Packet Guide

BAR 21-10-01

109-111 West Water Street, Tax Parcel 280013000

Project: Install roll-up doors in two storefront openings.

EXISTING LANDSCAPE PLAN

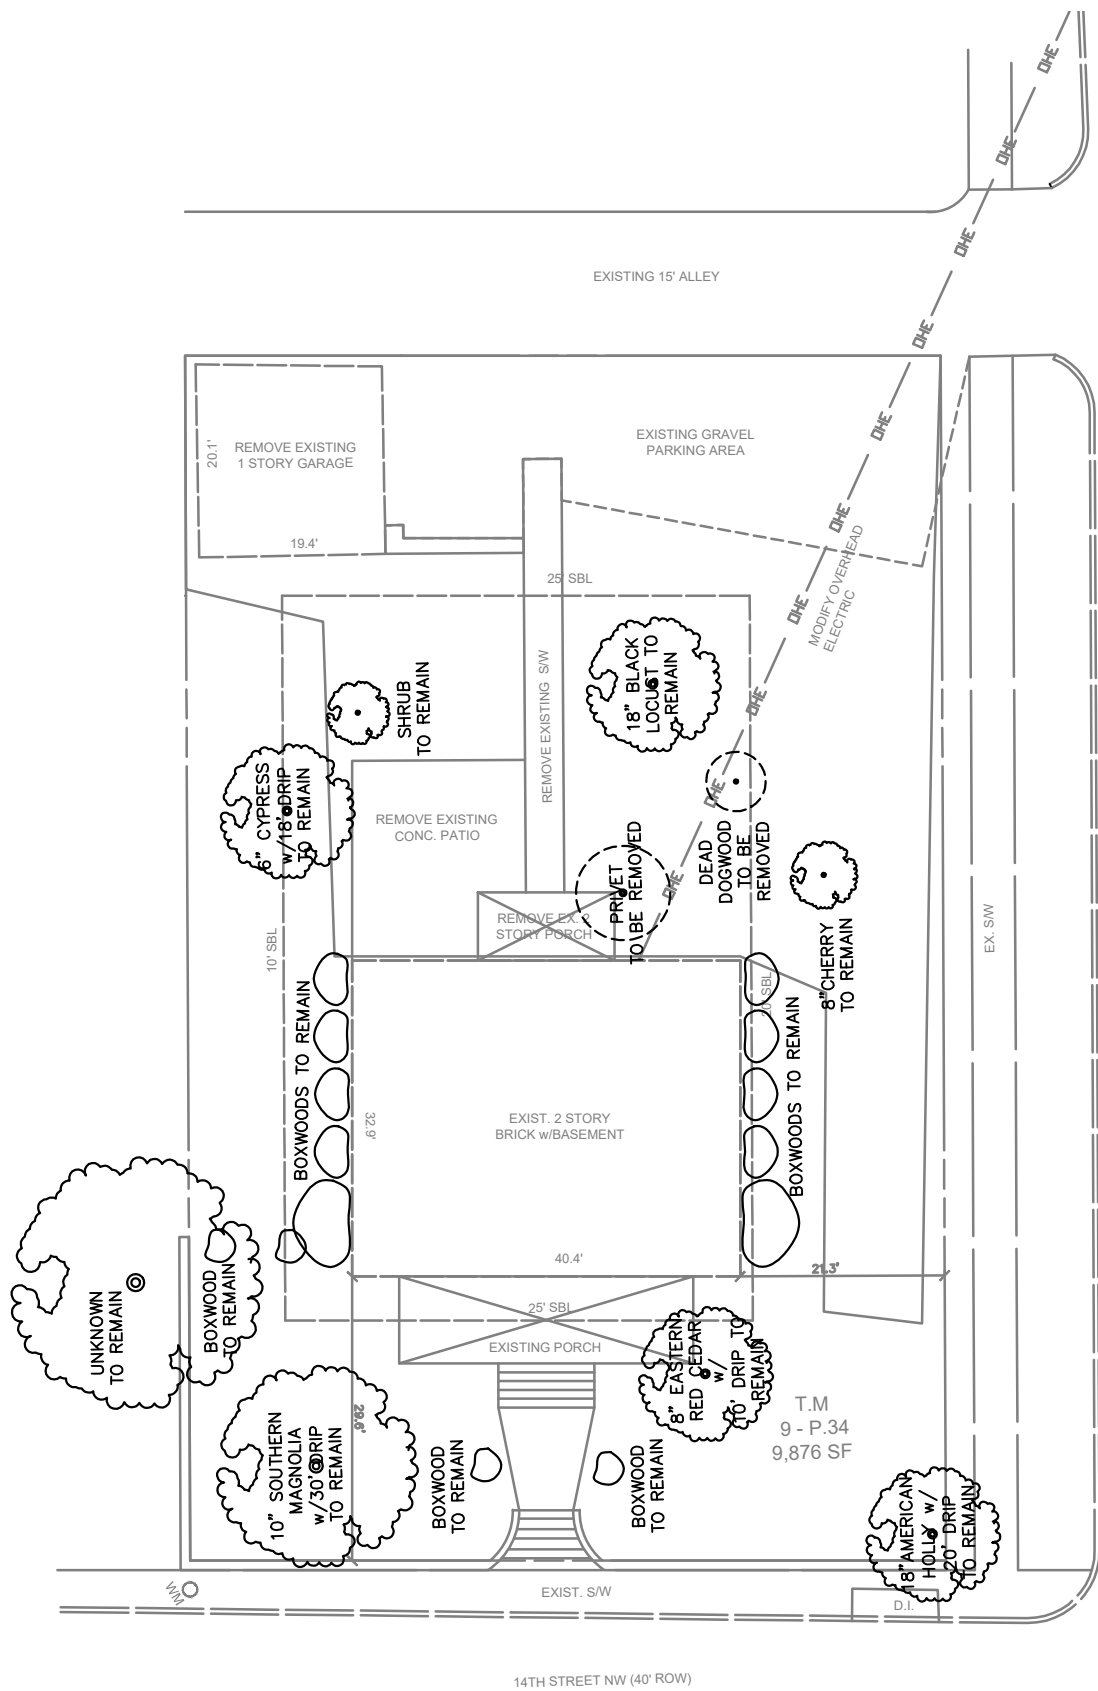
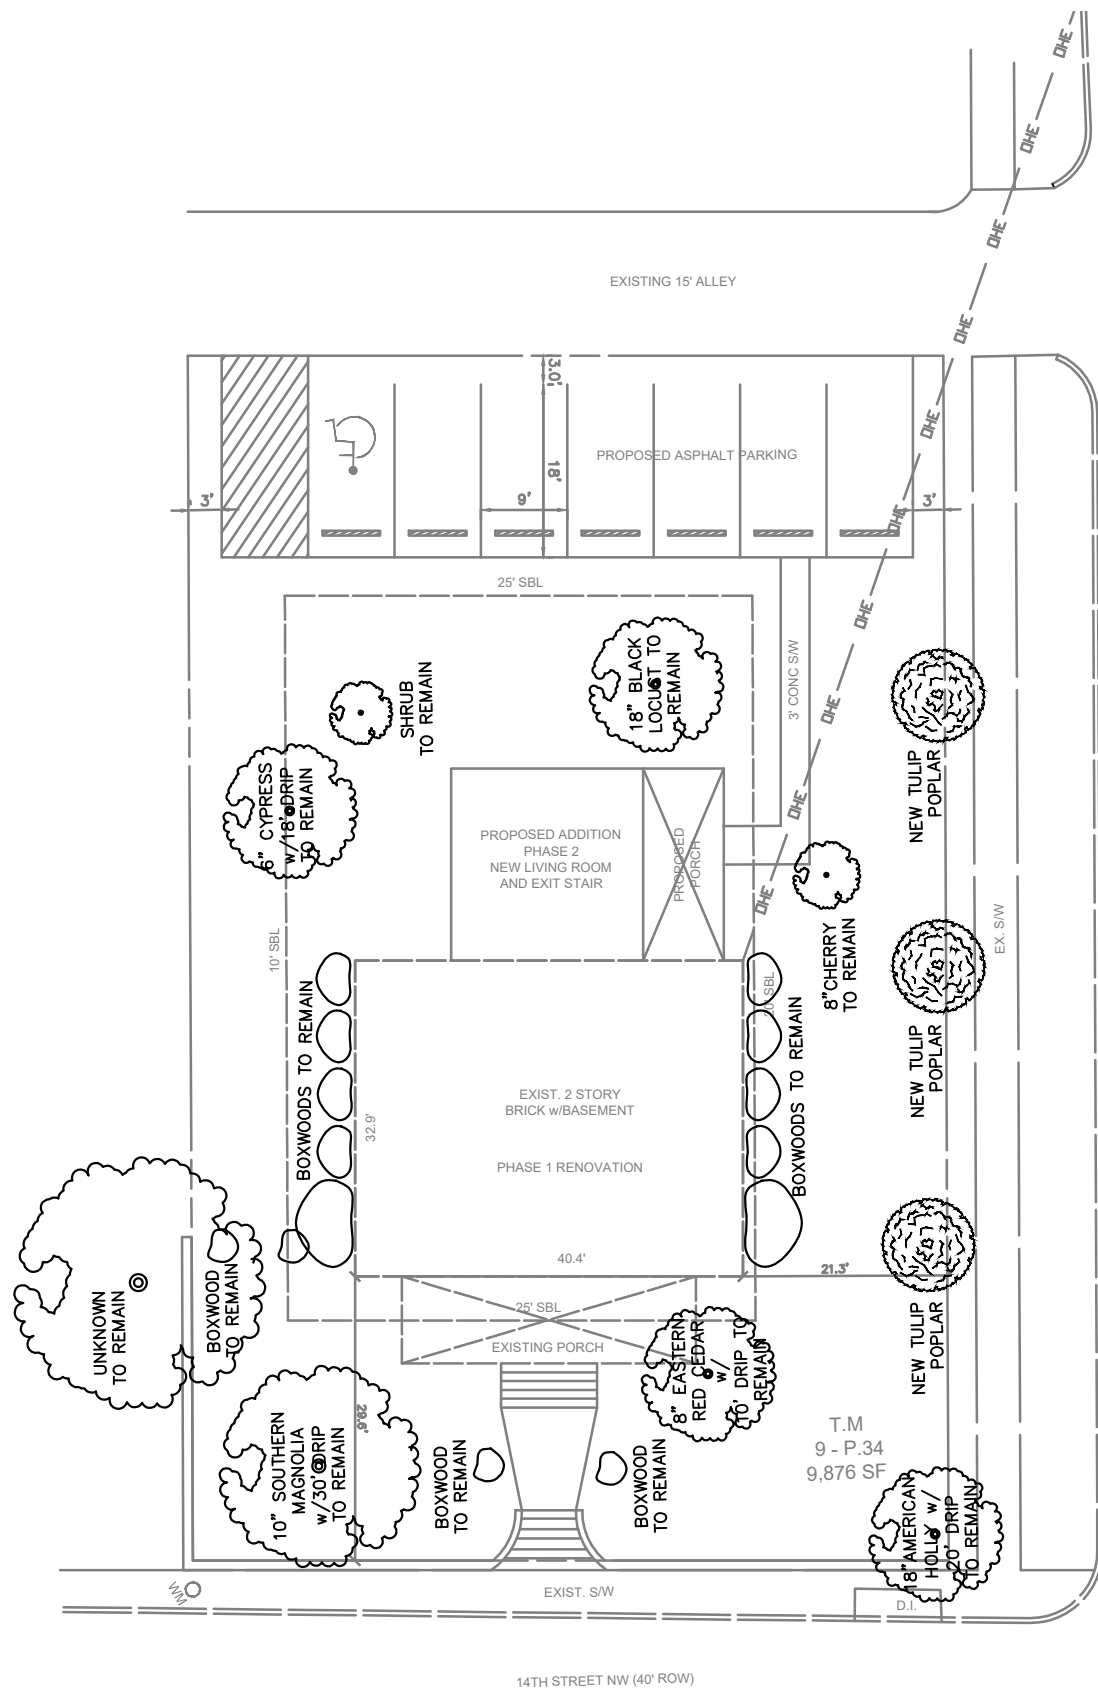
Mr. Schwarz – I am looking at your existing and proposed landscape plans. On the new plan, you have on the back corner an 18 inch black locust remain that doesn't show on the existing plan. Was that a mistake?

Mr. Wassenaar – In the phase III work, it would be demolished. It is a nice tree and one of the few trees that has any redeeming value. Unfortunately, it doesn't fit with the development plan that works in the fully developed phase. We would put in other trees to fill in that part.
